**RE: Construction Services
Emergent Care Plus – Primary Care Suite
2741 NE McBaine Drive
Lee's Summit, Missouri 64064
Project No. 122792**

REQUEST FOR INFORMATION

RIF #15

RE: plan note 3 sht.S201 beam bearing embed

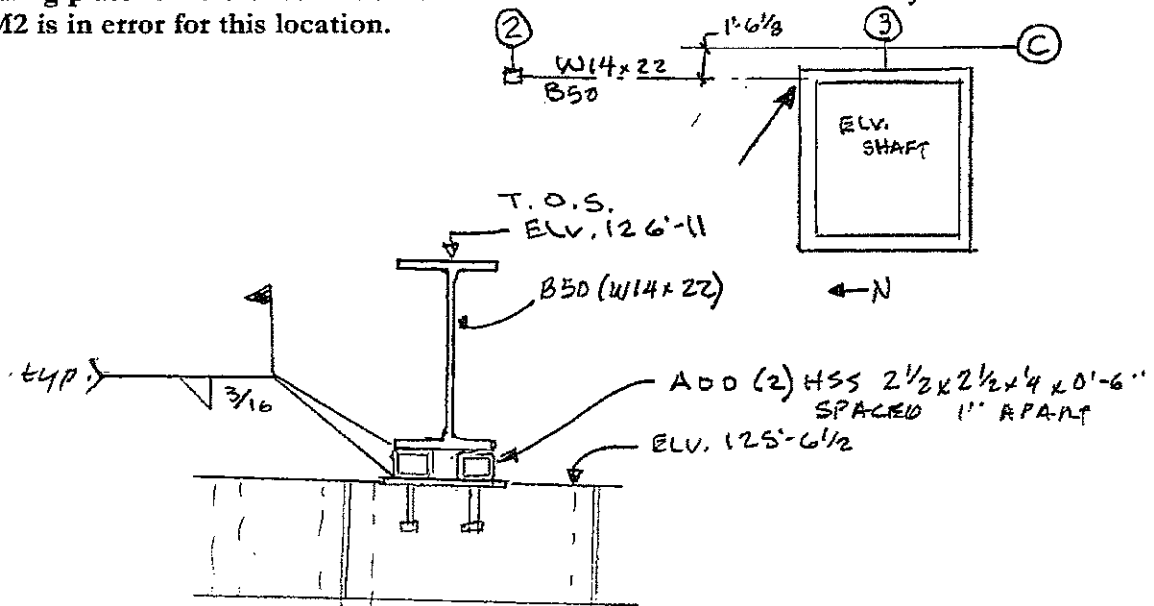
This is a confirming RFI to verify the phone conversation between John Funk of Hollis & Miller and Gene Asher of Doherty steel to use (2) HSS 2 1/2 x 2 1/2 x 1/4 x 0'-6" side by side, shimming the south end of roof framing beam B50 (W14x22) to the embed plate (see below).

The bearing plate for referenced beam was installed 2 1/2" low due to Doherty embed plan EM2 is in error for this location.

This is acceptable.
